PROJECT: Summitlin West V22 - Kestrel Creek Avenue (Street 1)

SUBMITTAL: 3rd Submittal & Supplement

CITY OF LAS VEGAS INTER-OFFICE MEMORANDUM		DATE: August 4, 2020
TO: Land Development Services Department of Building & Safety		FROM: Albert Sung, P.E. Flood Control Project Engineer Department of Public Works
SUBJECT: Drainage Study for: Summerlin West V22 – Kestrel Creek Avenue (Street I) (from Desert Foothills Drive to Kettle Ridge Drive <Street J>)		COPIES TO: Atkins
Cross Streets:	Desert Foothill Drive & Kestrel Creek Ave.	Howard Hughes Company, LLC
File Number:	F:\Depot\DSMemos\DS5171D.doc	Bart Anderson, P.E., DevCo
Parcel Number:	137-14-401-006 & 137-23-101-002	
Zoning Action:	N/A	
FEMA Flood Zone	YES	NO X
Proposed Storm Drain	YES X	NO

**RE: UPDATE #1 TO THE TECHNICAL DRAINAGE STUDY FOR SUMMERLIN WEST VILLAGE 22
KESTREL CREEK AVENUE: DESERT FOOTHILLS DRIVE TO KETTLE RIDGE DRIVE
(STREET J)**

TECHNICAL DRAINAGE STUDY FOR SUMMERLIN WEST VILLAGE 22
KESTREL CREEK AVENUE UPDATE #1
STREET I (DESERT FOOTHILLS DRIVE TO STREET J)
FIGURE 4: HYDRAULIC WORKMAP

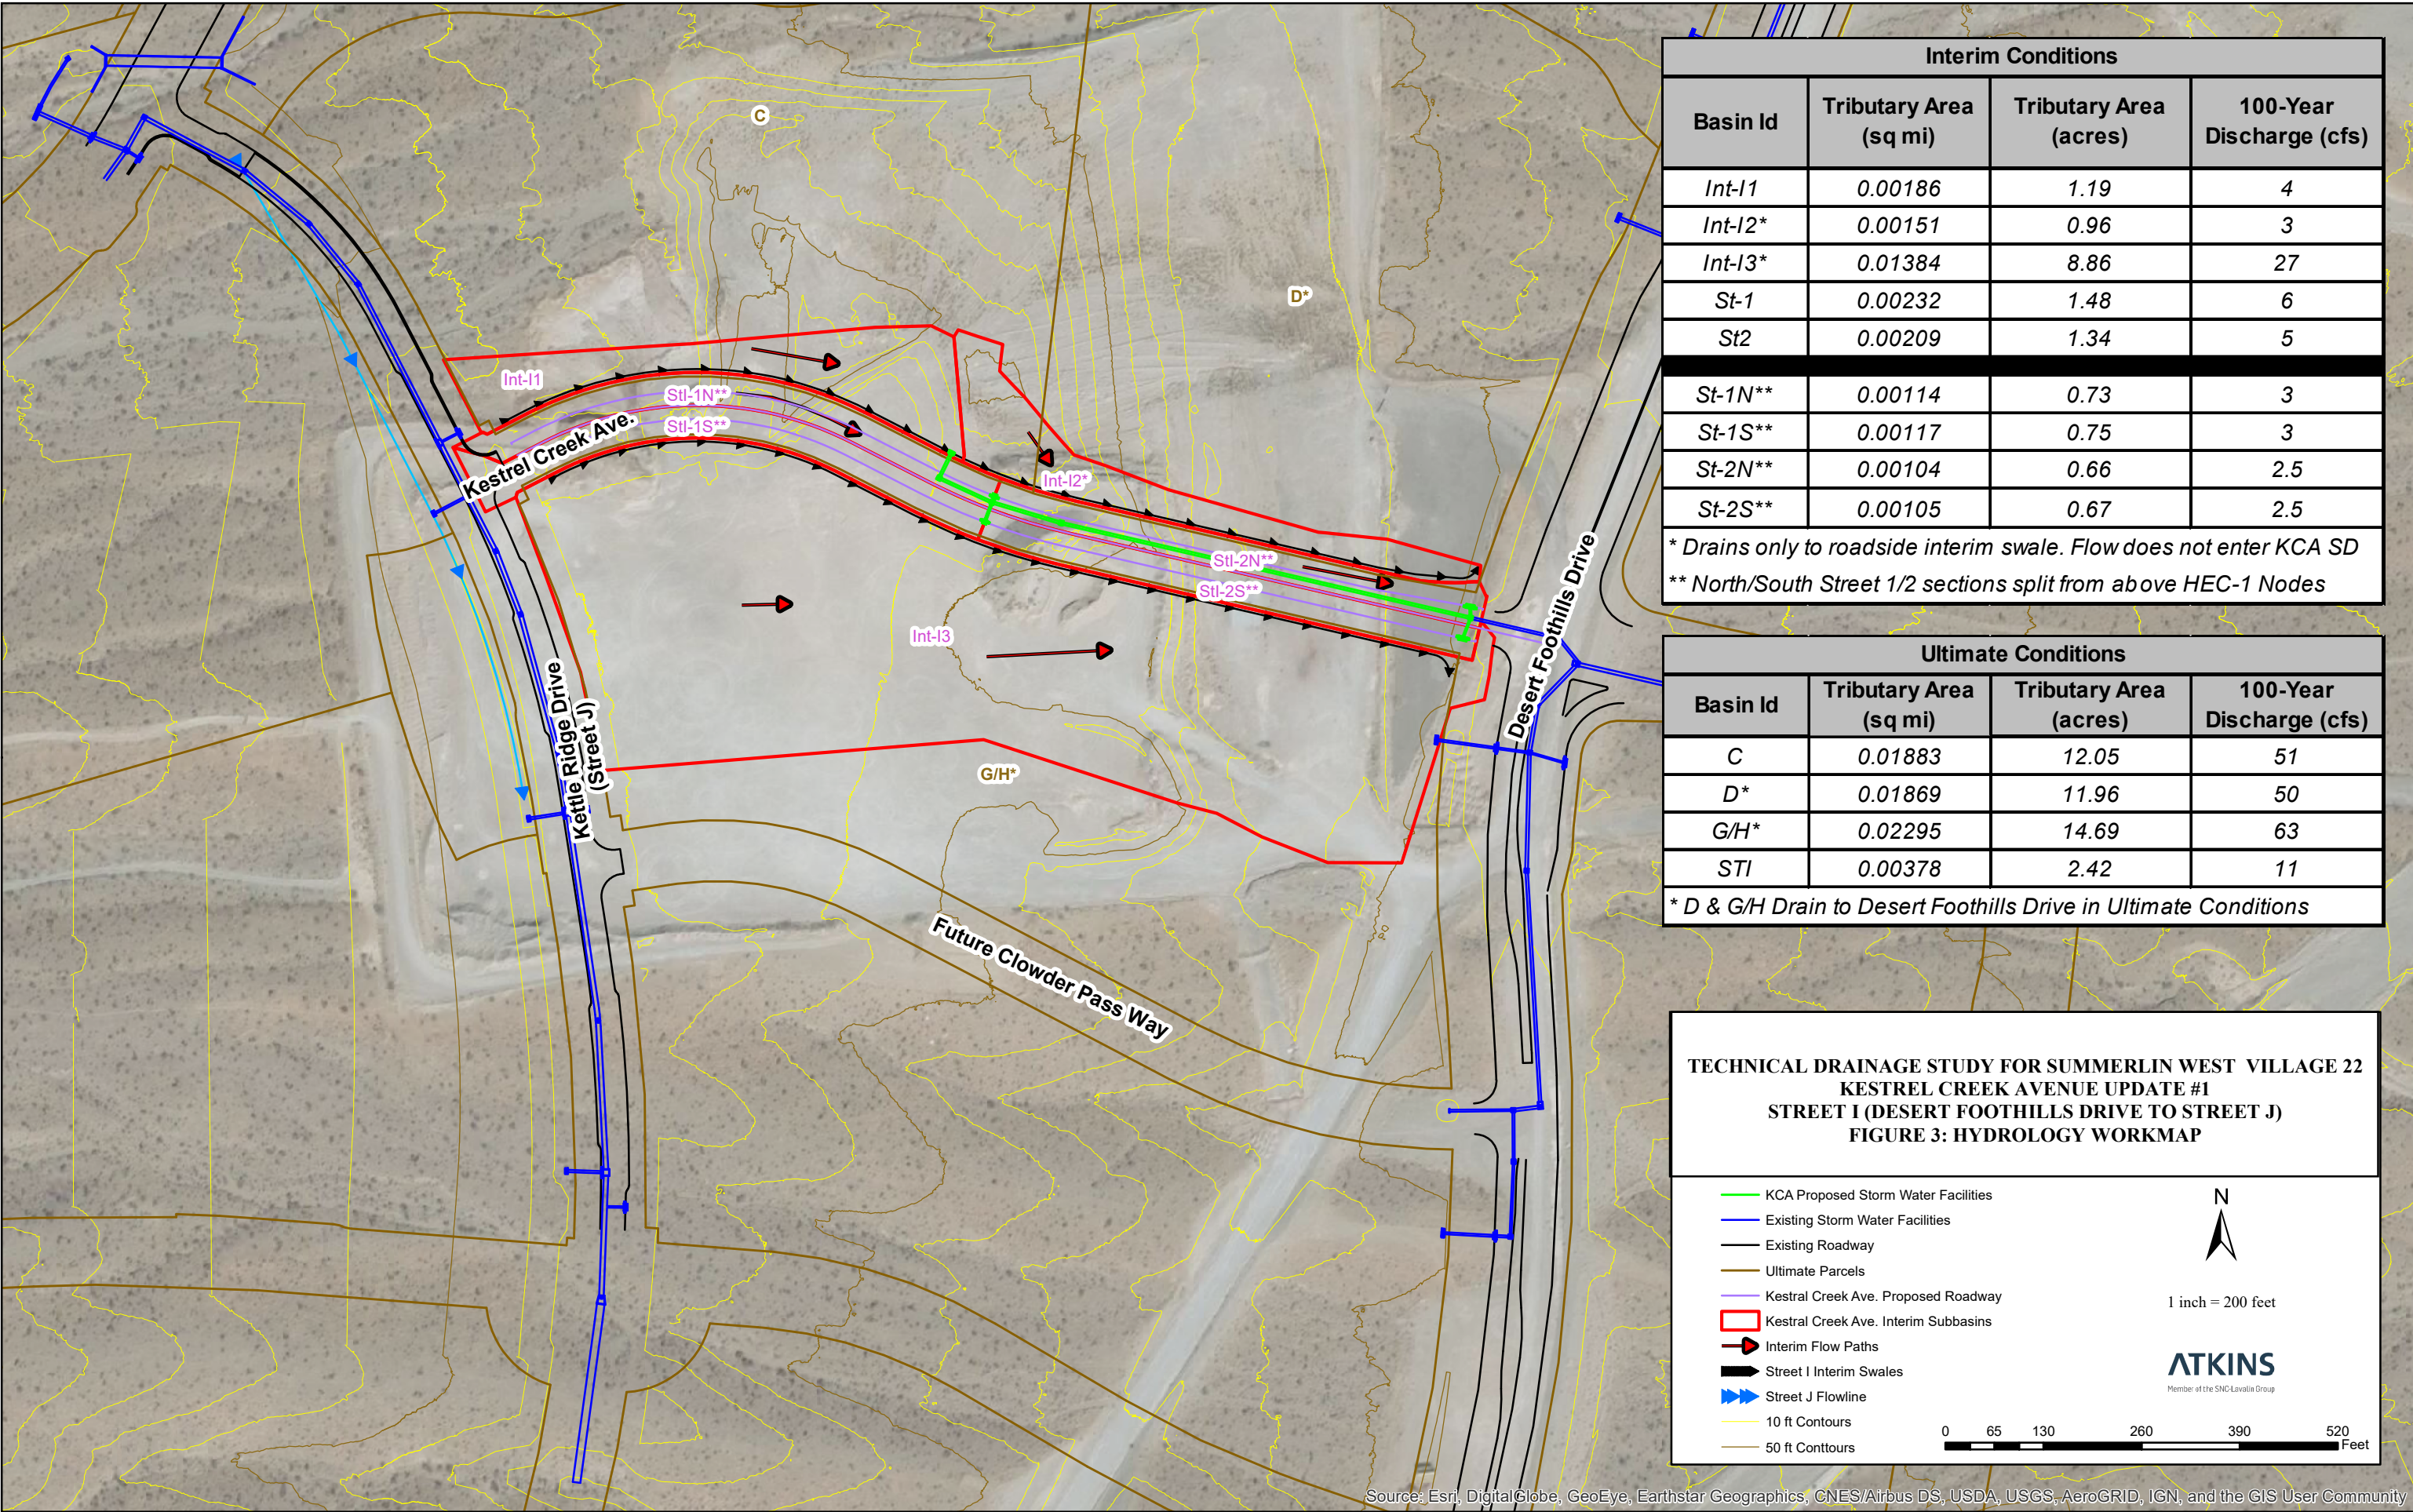
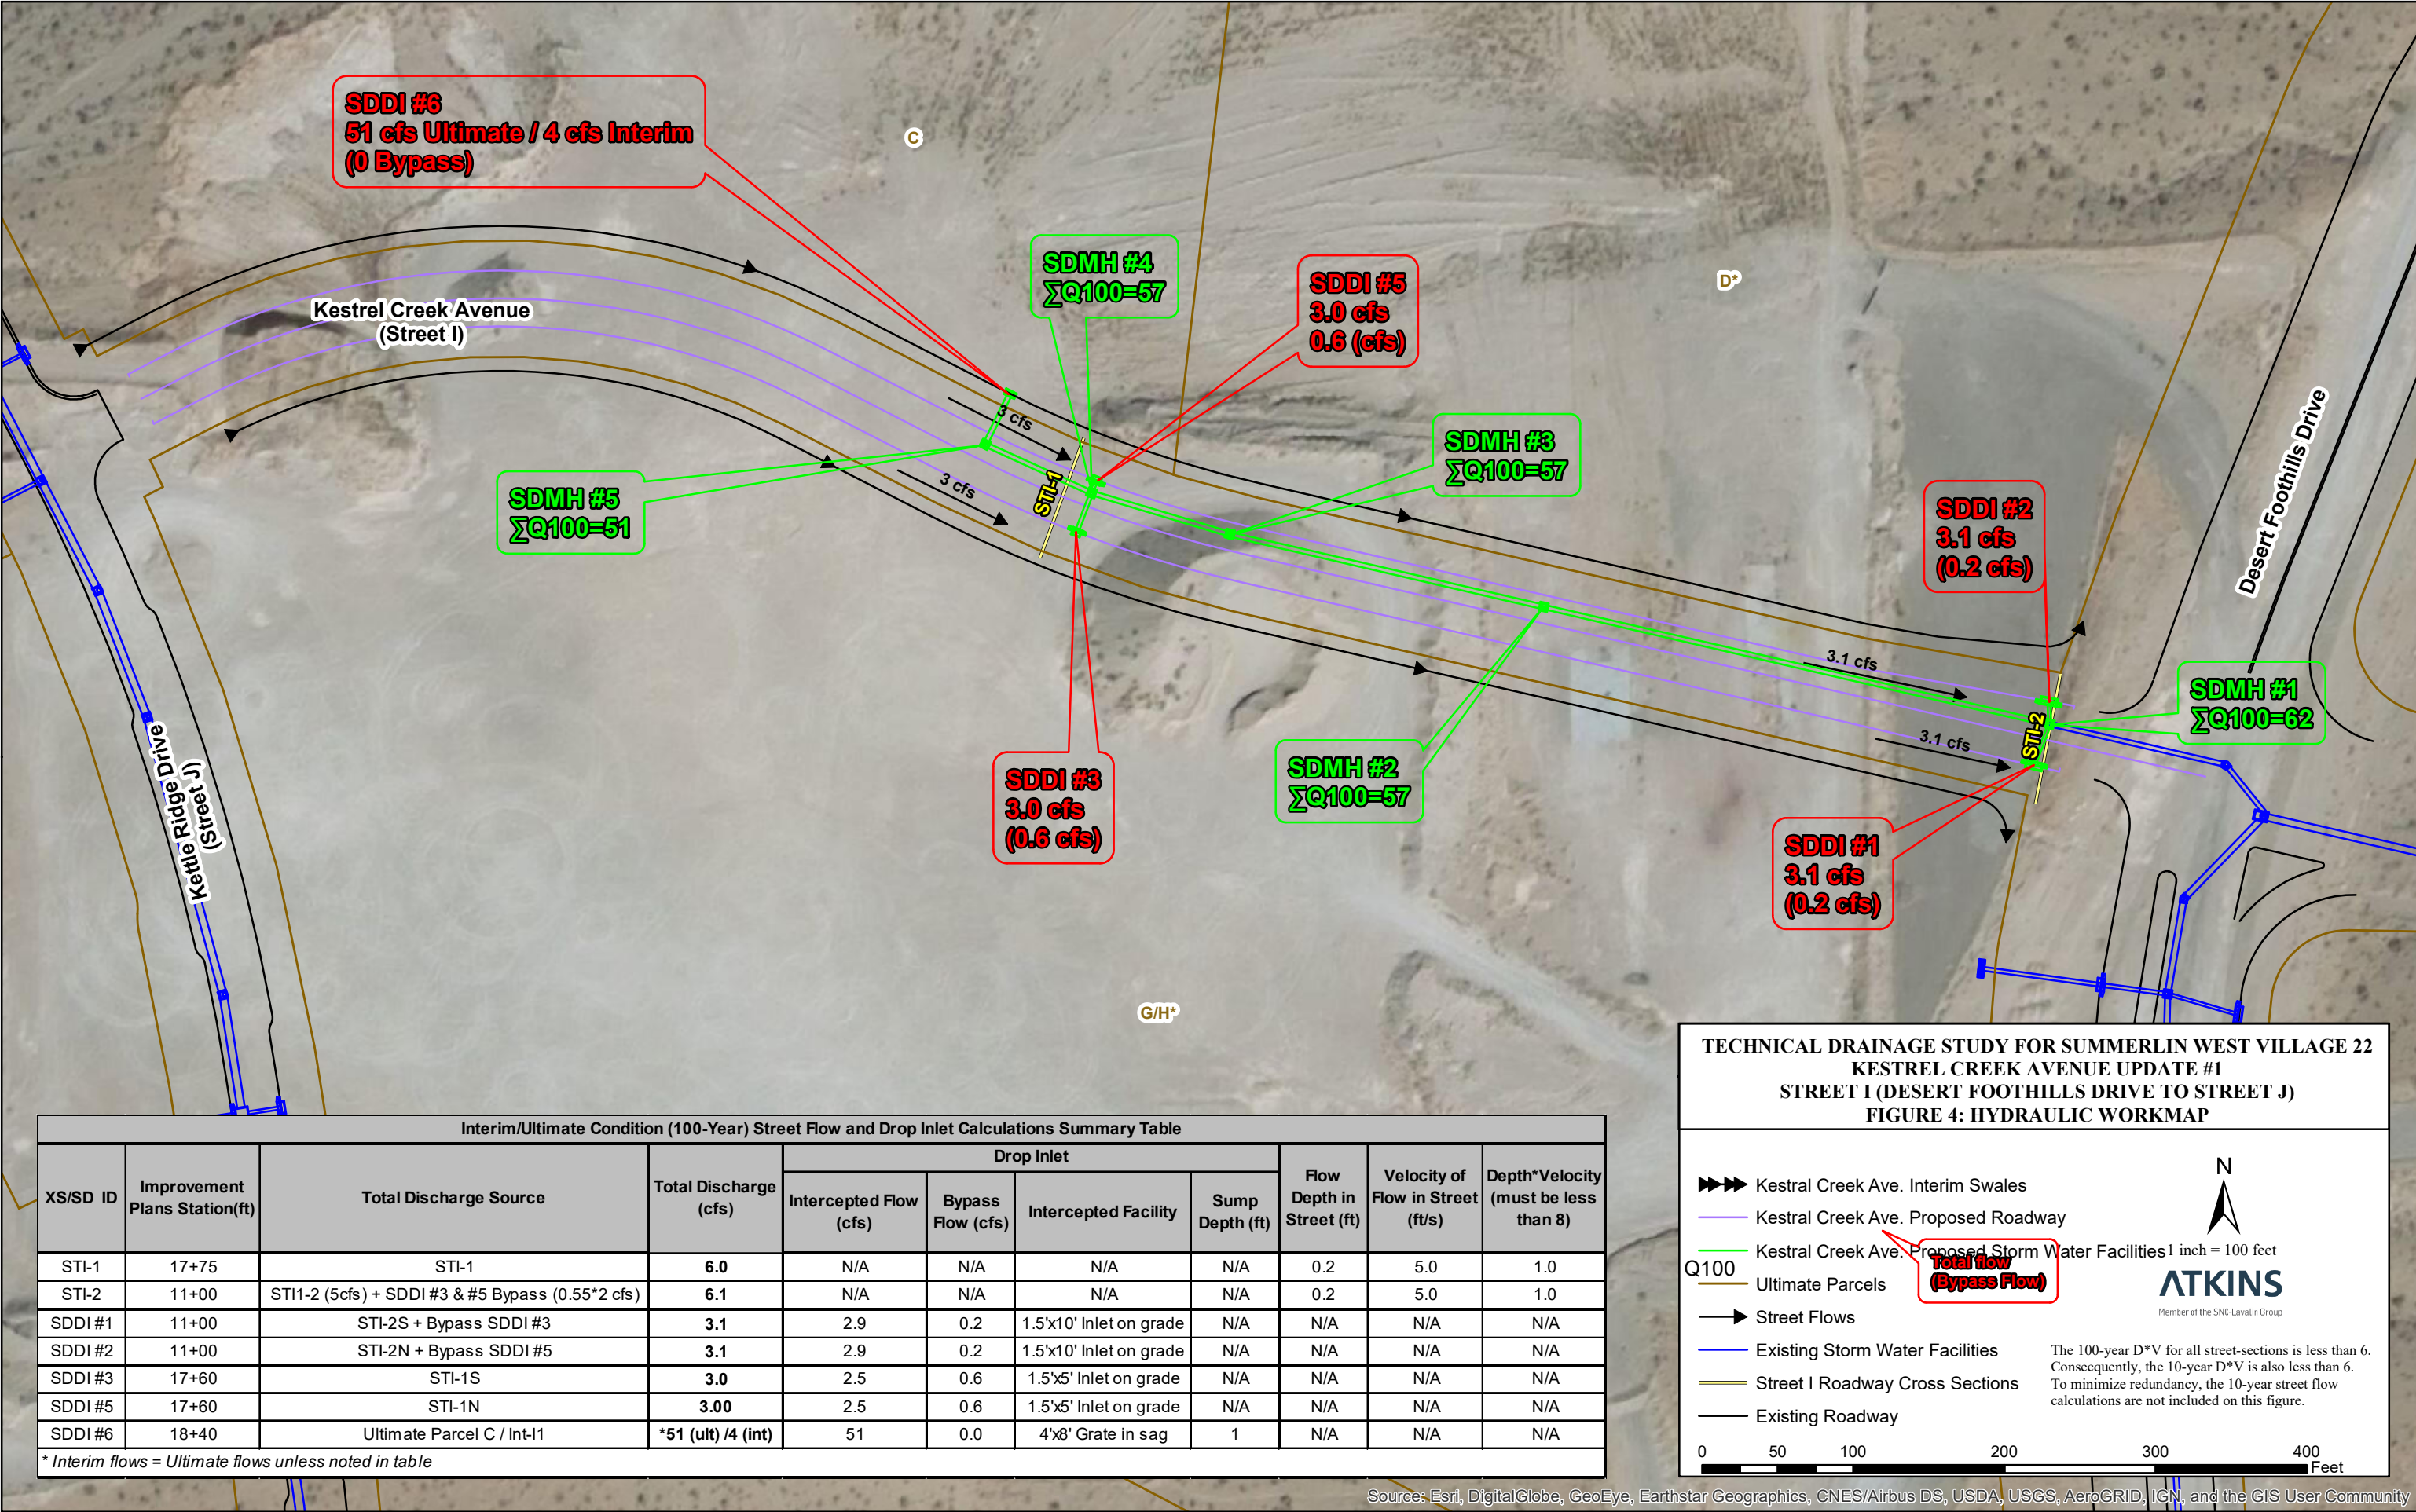
The interim condition flows have been revised due to the removal of parcel grading and the berm and swale between parcels C&D. The stub for Parcel G to the south has also been removed. The stub is now located on the Desert Foothills Drive alignment and plan set, which is reflected in the TDS Update #1 to Desert Foothills Drive, under review concurrently with this one.
